**REVIEW OF ENVIRONMENTAL FACTORS (REF)
SOUTHERN BOAT RAMP UPGRADE – ULLADULLA HARBOUR
ULLADULLA**

Item	Details
Project	Review of Environmental Factors – Southern Boat Ramp Upgrade – Ulladulla Harbour
Client	City Services, Shoalhaven City Council
Prepared By	City Services, Shoalhaven City Council

Table 5. Consideration of TfNSW comment

C-01-00-02

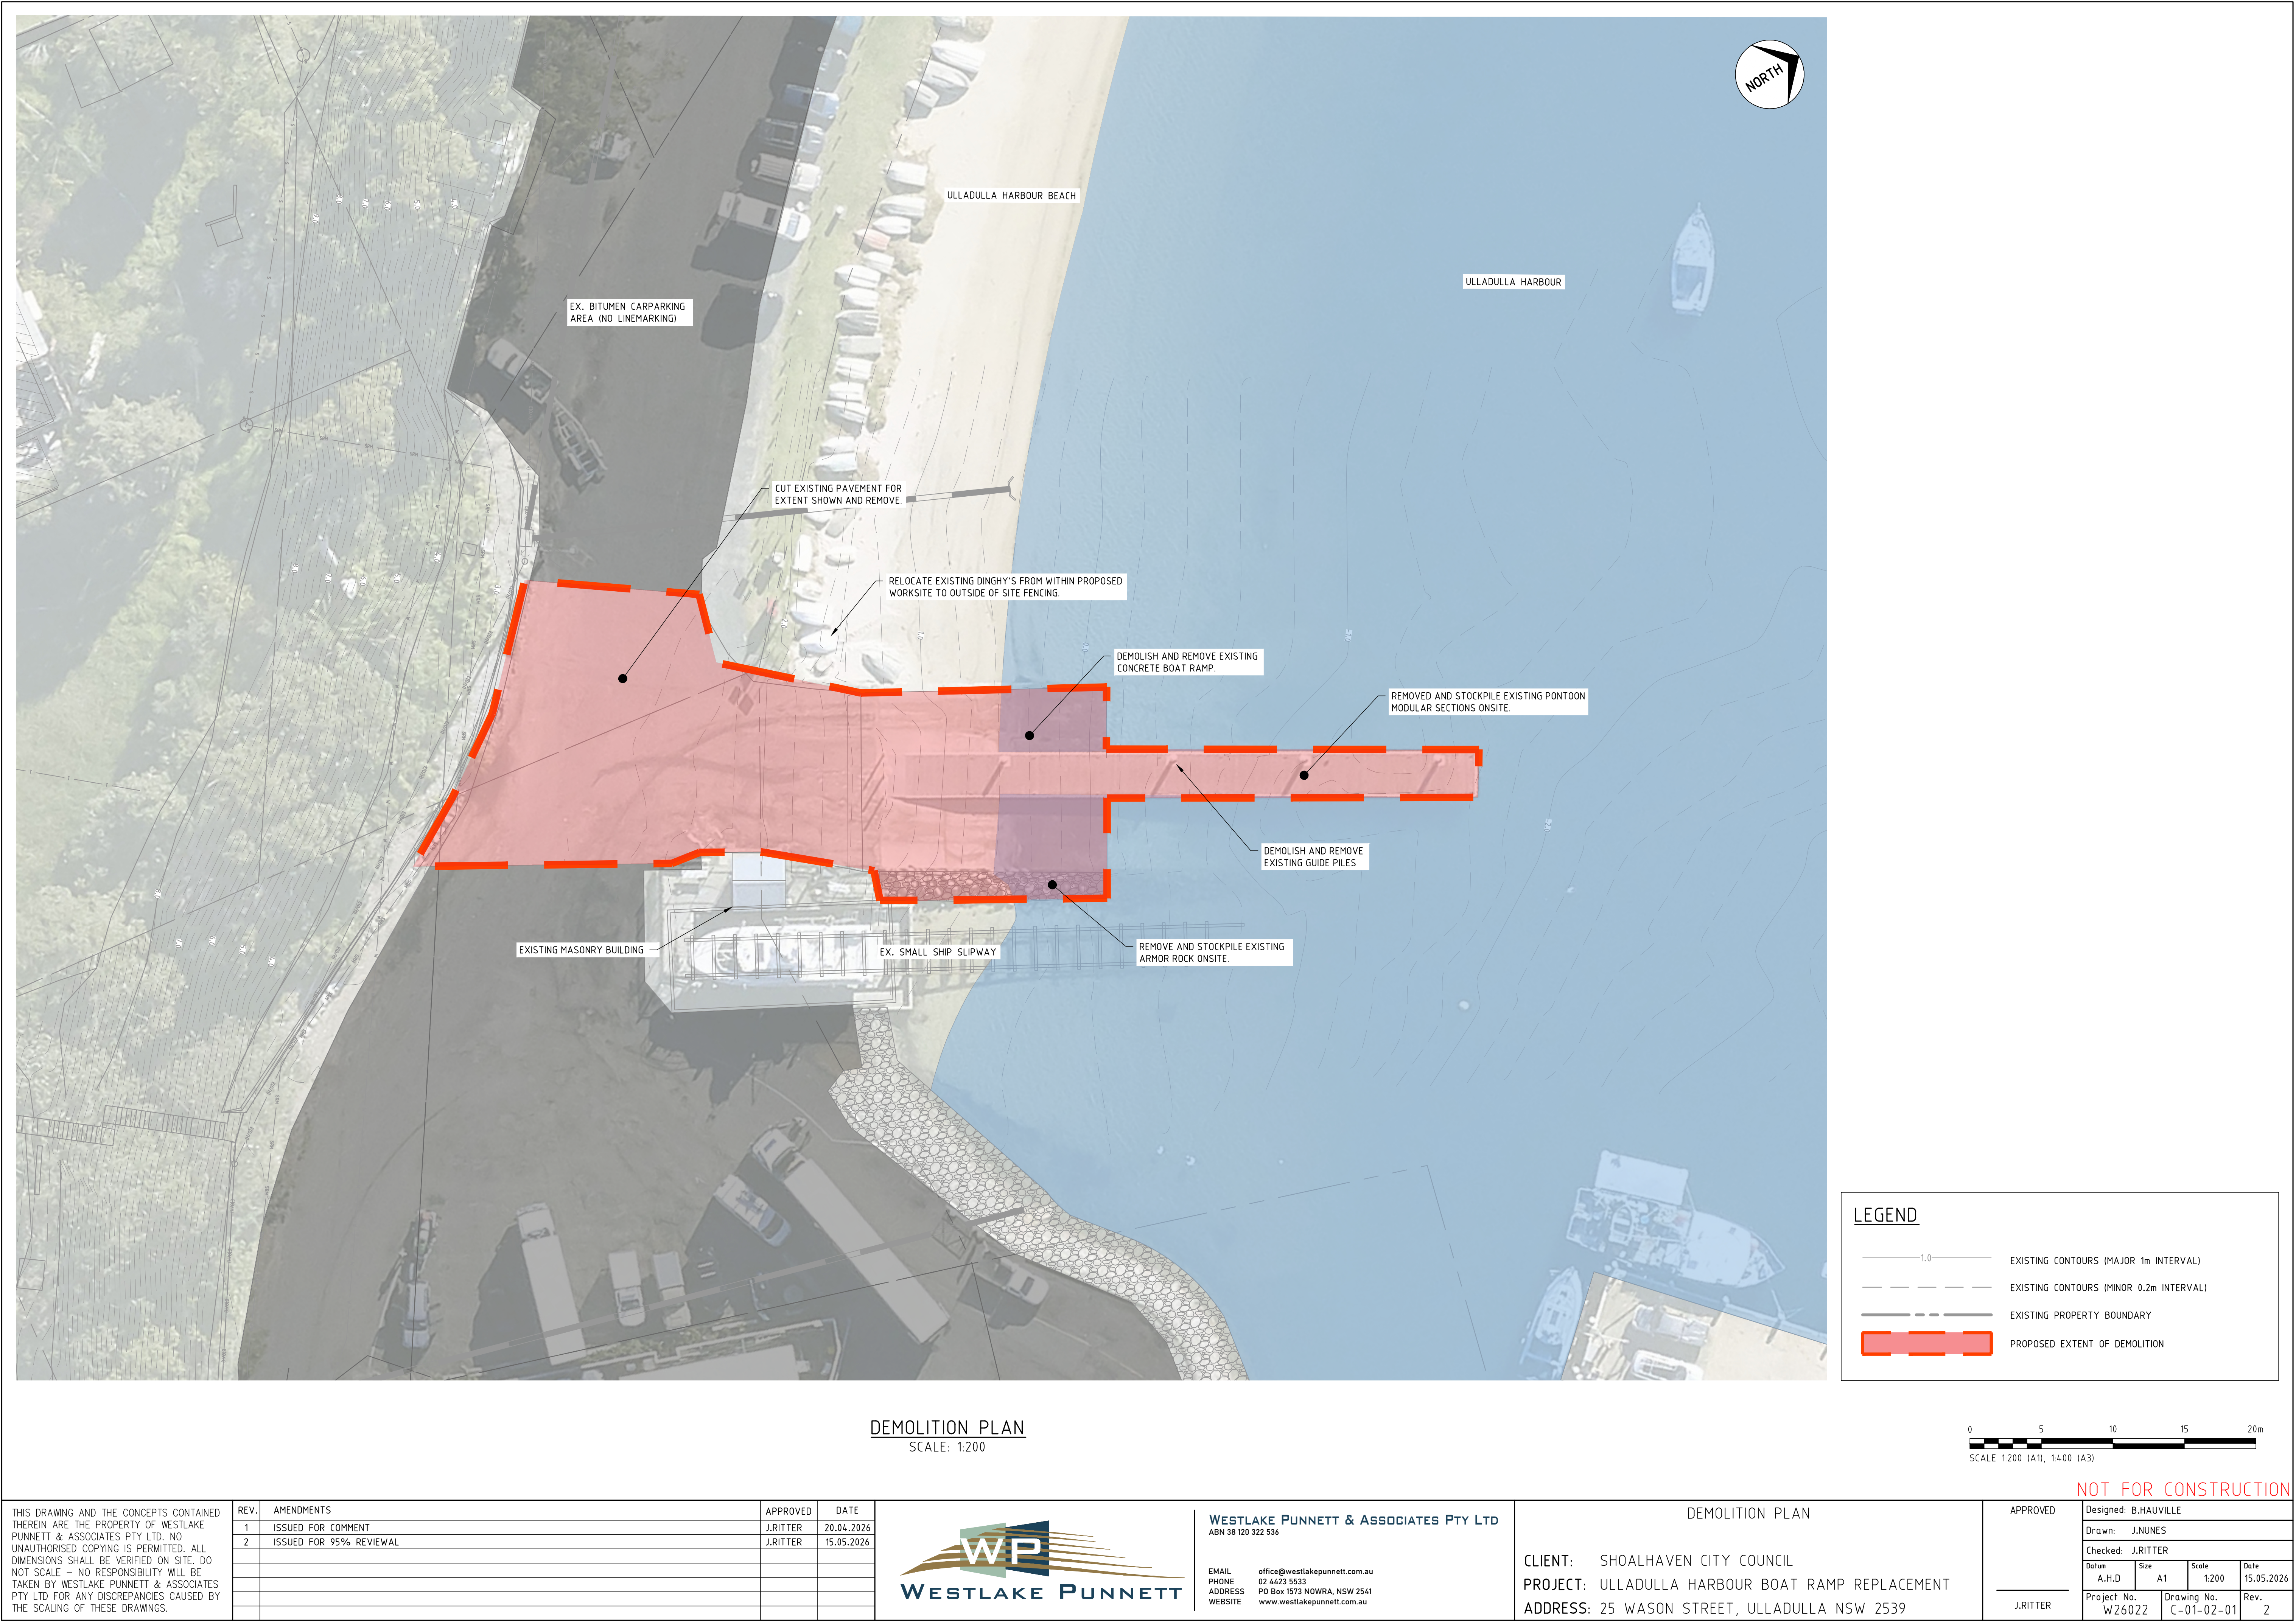
TfNSW comment	SCC consideration response
Drawing C-01-00-02 The construction drawings refer to "the contractor" both as the "CONSTRUCTOR" and the "CONTRACTOR"? Please clarify in the drawings consistency throughout and refer to the party that has won the contract to build the boat ramp as "the contractor" and not to interchange throughout the drawings, contractual documents and specifications. There needs to be consistency in the drawings and specification of the roles of the CONSTRUCTING AGENT & Head Contractor.	The design consultant has been requested to make terminology consistence throughout the drawings to be "the contractor".
Structural Steel Notes In the construction drawings the use of dissimilar grades of stainless steel has not been identified to ensure that a 25-year design life is achieved (nuts and threads) similar corrosion rates that will freeze nuts to the threads Please confirm if timber piles are to be used and remove updated notes that reference timber piles if they are not being installed.	The design consultant has been requested to include the full description and clarify abbreviations for stainless steel (SS) to include the grade 316 for all SS elements. The design consultant has been requested to remove all notes and comments that are related to timber piles. Steel piles are to be provided.

DRIVING ONTO TRAILERS SIGN DETAIL
SCALE 1:5

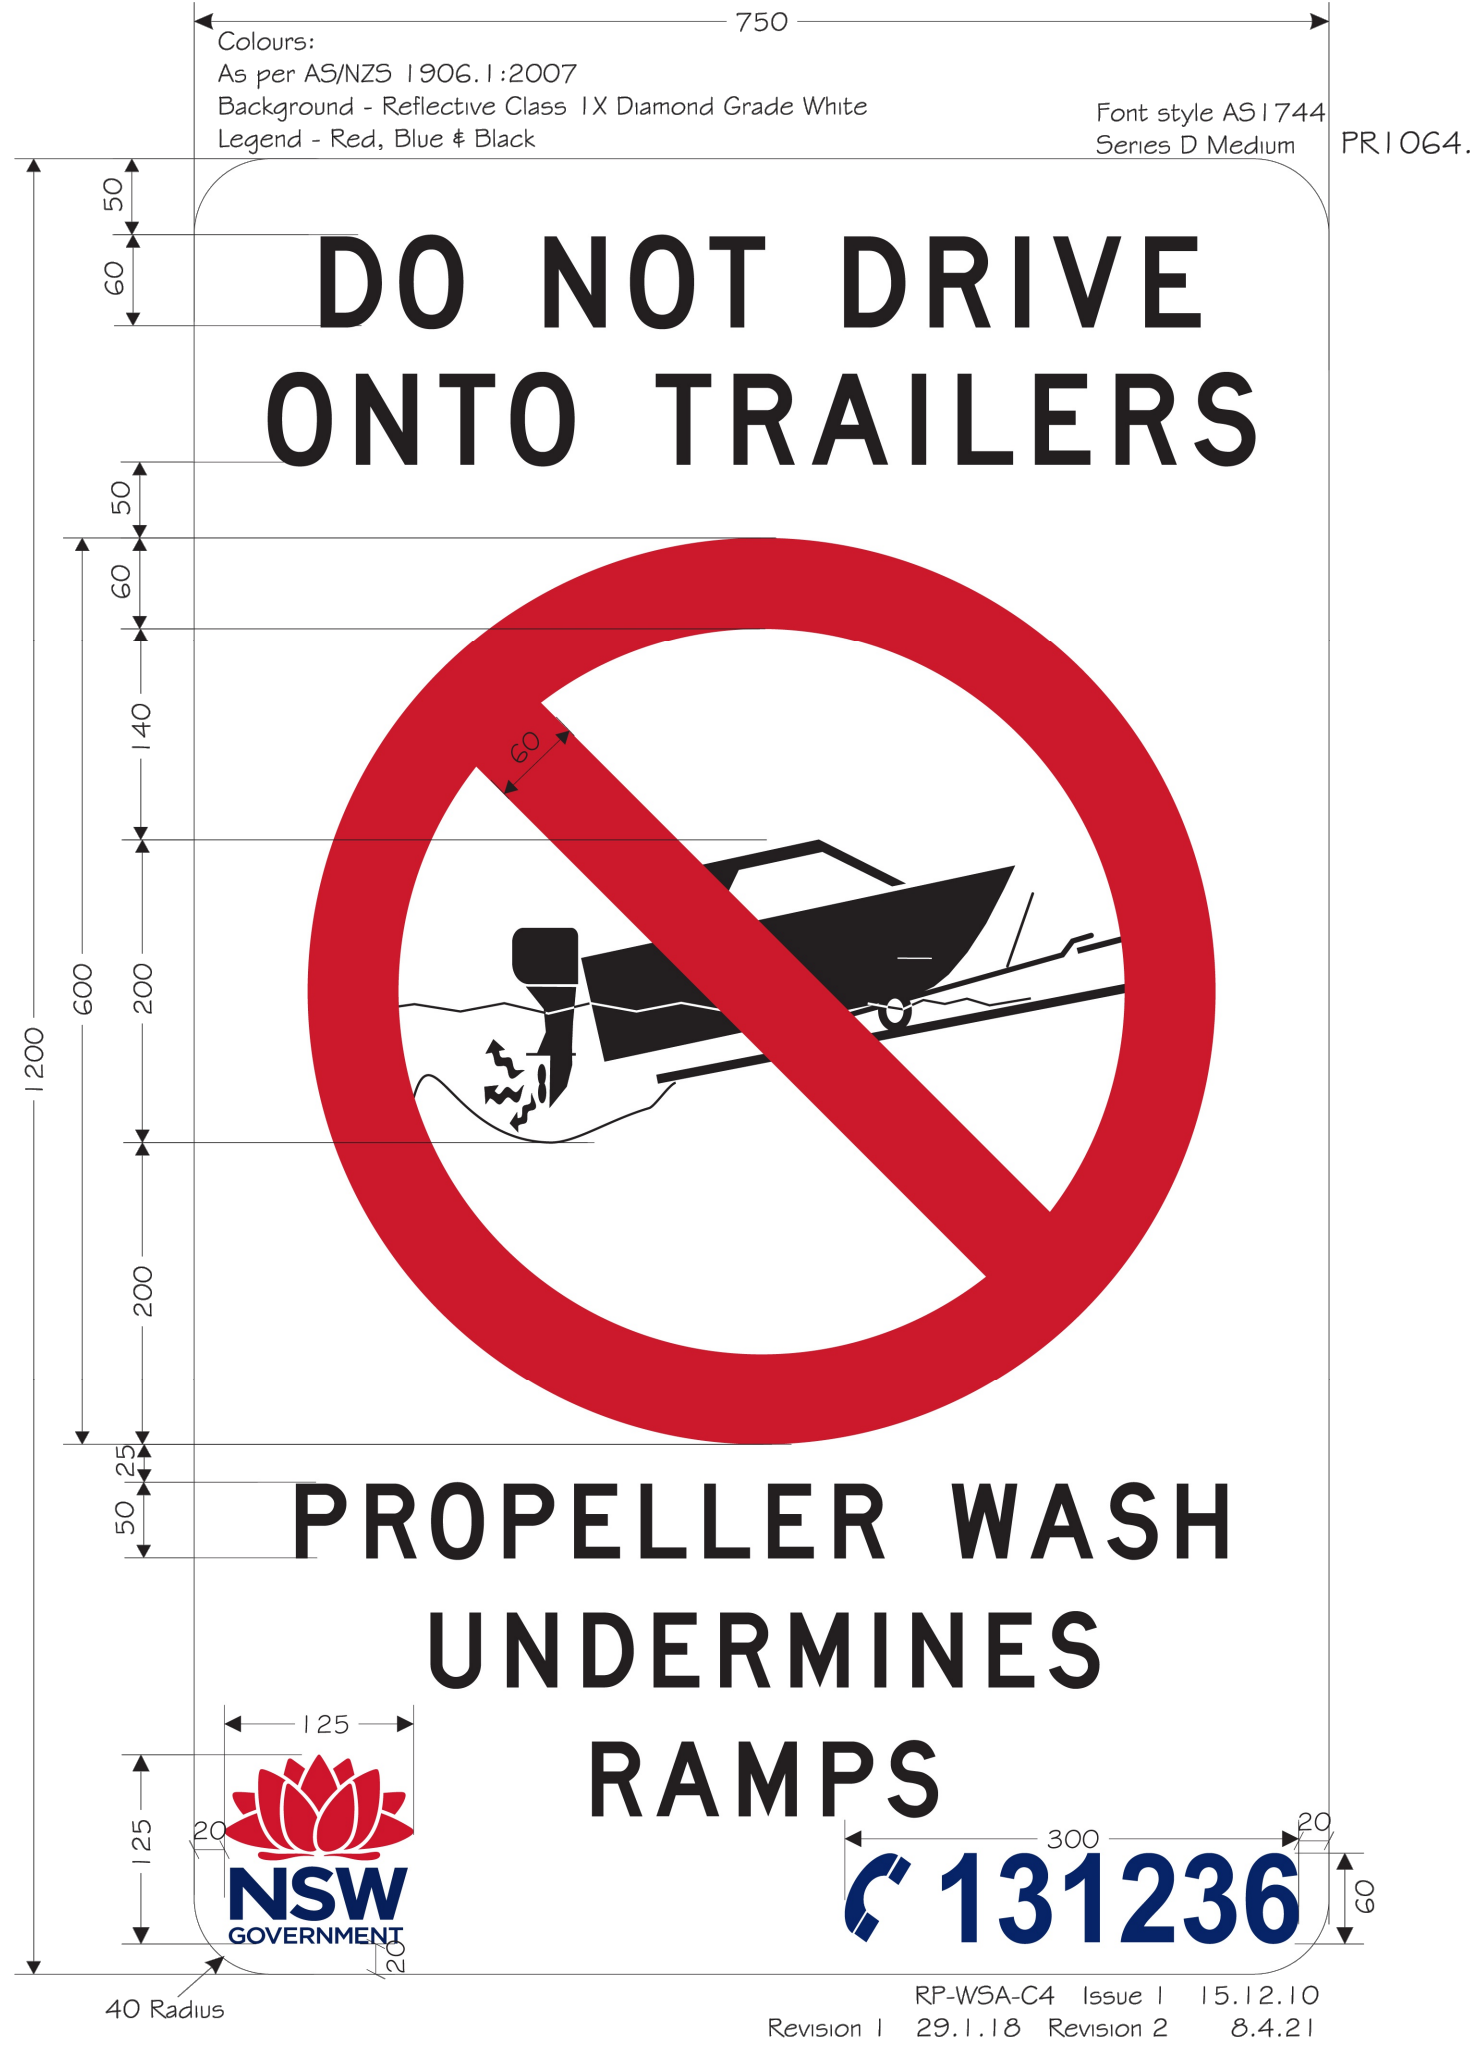
Drawing C-01-12-02 TfNSW-Maritime suggests that the General Boating Safety information is the preferred option is lieu of the 'Do not drive on trailers' sign.	A request for clarification was sent to TfNSW on 25 June 2026. It stated: <i>"Could you please provide clarification regarding the design and supply of the "General Boating Safety Information" sign? My understanding, based on a previous project and advice from Tim Woolnough (TfNSW - Grants and Projects Maritime Infrastructure Delivery Office NSW Maritime), is that the messaging and panels for this signage are developed and supplied by Maritime South (and is site specific) – these Symbols come from Maritime's signage options and do not necessarily include council management or regulatory responsibilities for the facility i.e. it is for Boating Safety Information (compliance or regulatory signage is normally kept separate)."</i>
